Planning application reference: AL/107/21/PL

Woodgate Centre, Oak Tree Lane, Woodgate, PO20 3GU

Technical Note

Response to Committee Deferment Clarifications

Figure 2.1: Street Inventory Tuesday 8th Dec 20

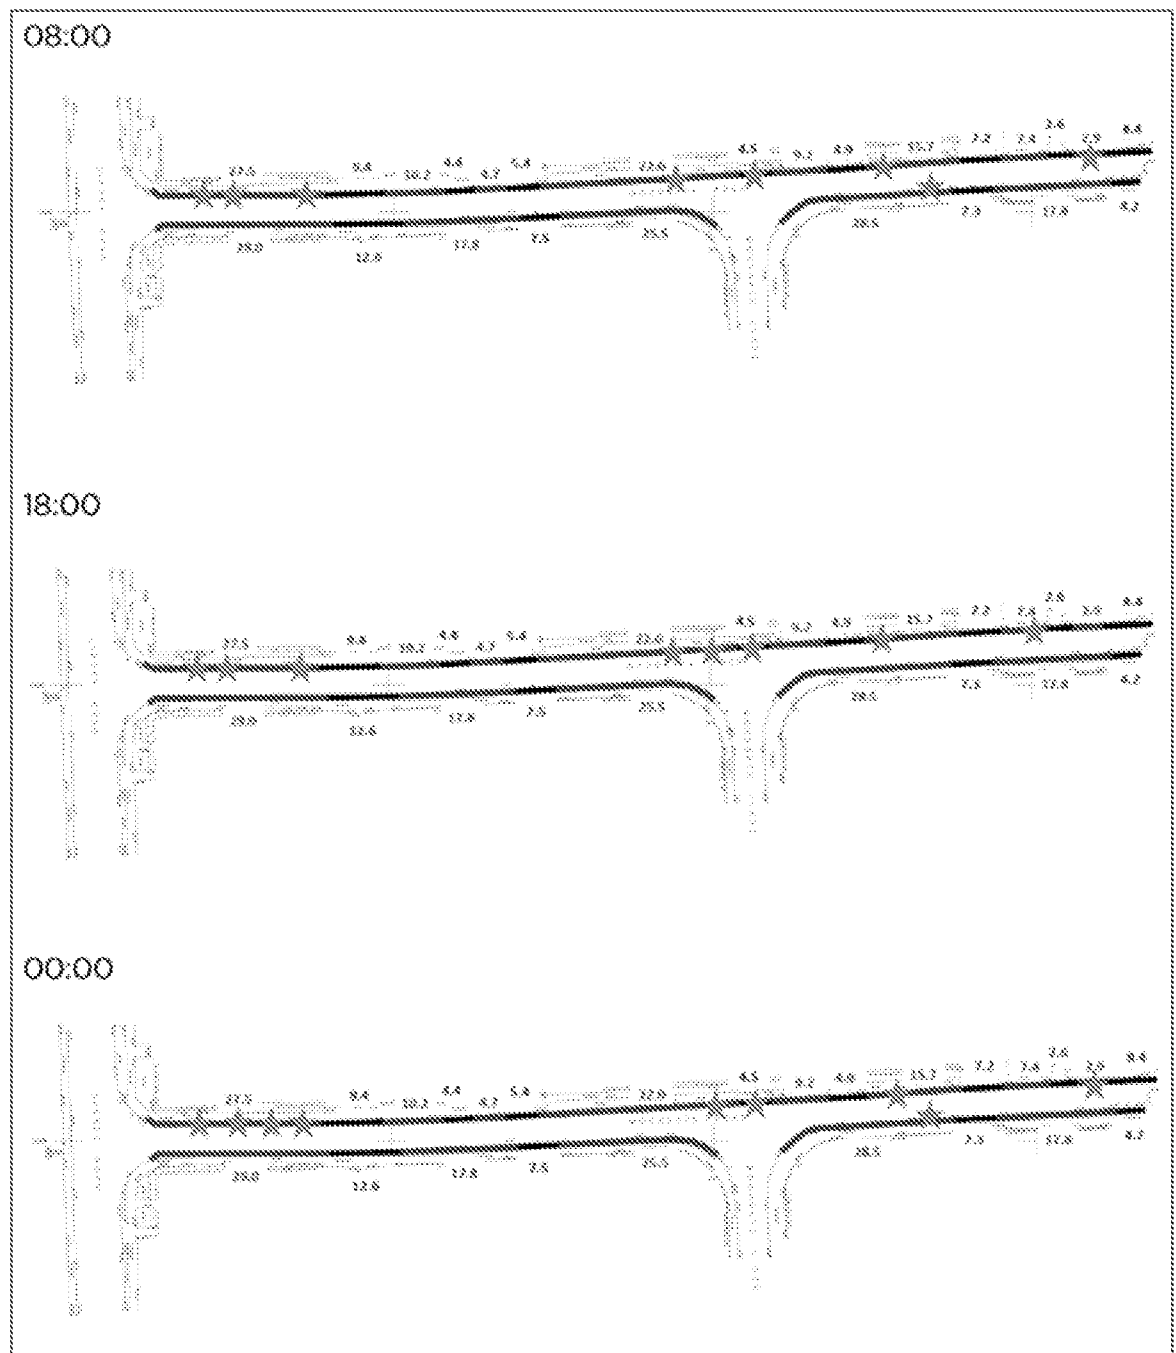
In recognition of the on-street parking, an independent, existing on street carparking assessment for Woodgate Road was undertaken. This was prepared and submitted to West Sussex County Council Highways Department (WSCCH) as part of the suite of Highways documentation to support the application. This assessment was underpinned by a parking survey undertaken from Tuesday the 8th to Wednesday the 9th of December 2020 inclusive.

This survey confirmed that there are 23 bungalows who gain direct access from Woodgate Road and although the majority of these have driveway provision, there are four bungalows who do not have driveway provision.

These bungalows are situated directly opposite to the junction with Woodgate Close and it is apparent that the cars belonging to these are parked on street as can be surmised from the parking inventory plans provided below.

It is also identified that some on the dwellings towards the end of Woodgate Road did not use their driveway at the time of the survey and parked their cars on street. It is therefore reasonable to consider the surveyed parking is the worst-case scenario.

Table 2.1 below summarises the parking utilisation on both survey days. On-street parking can be observed in approximately 25% of the overall length of Woodgate Road.

It can be seen from the location of the on-street parking that while vehicles may need to give way to on coming vehicles due to the on-street parking there is sufficient carriageway that is not parked on to enable such a manoeuvre safely. Indeed, national guidance in the form of 'Manual for Streets' paragraph para 7.4.4, confirms that on-street parking provides a form of proxy traffic calming to slow vehicles down. Refer extract bullet point 6 below:

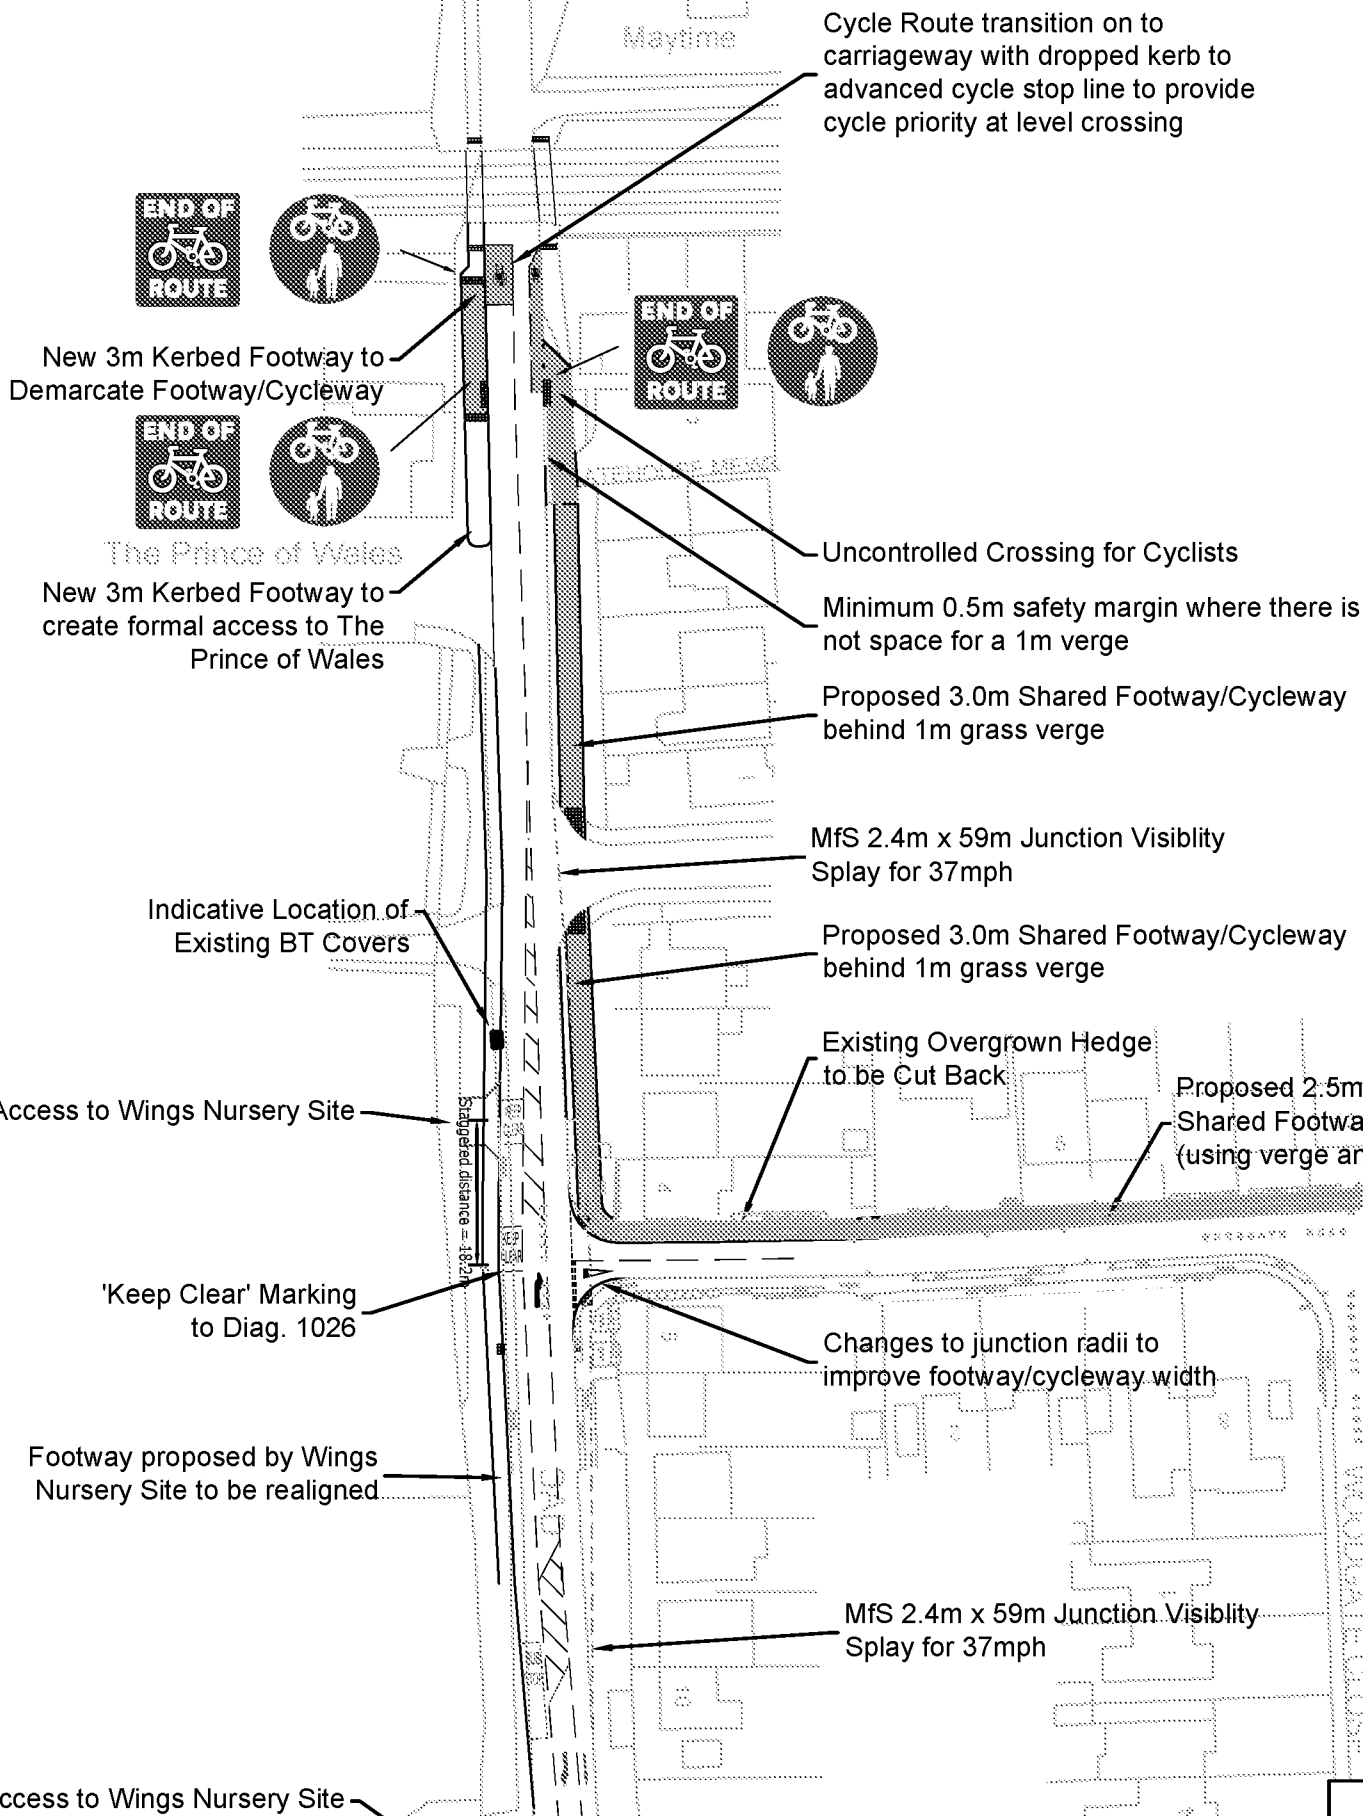
It appears that the planning committee has not been made fully aware of the surface water regime to be implemented on site. A full flood risk assessment incorporating sustainable urban drainage techniques has been submitted to and approved by West Sussex County Council as the Lead Local Flood Authority. In addition, Arun's drainage engineers have been consulted and neither have objected.

A geotechnical investigation was undertaken, and it was found that the subsoil was NOT conducive to infiltration techniques to fully deal with the surface water generated by the development.

It was therefore concluded that for the surface water management train, control at source would be undertaken via porous paving within private driveways with pipes and swales interconnecting to a balancing pond within the open space in the northeast corner of the site.

This then discharged to the Lidsay Rife controlled to less than greenfield runoff known as Qbar. With all storm events up to 1 in 100 plus climate change attenuated via the pond and porous paving system further upstream. This not only will prevent flooding on the site and downstream but will also ensure water quality to the Rife.

The outfall from the attenuation pond will be via a defined ditch to the Rife as illustrated on the appended drawing 20-061-007 Rev M. It can be seen that infiltration will not be used on the site for surface water control. As such the proposed SuDs scheme does not utilise infiltration as suggested at the committee to control surface water runoff from the development. Nor does it increase flooding on or off the site.
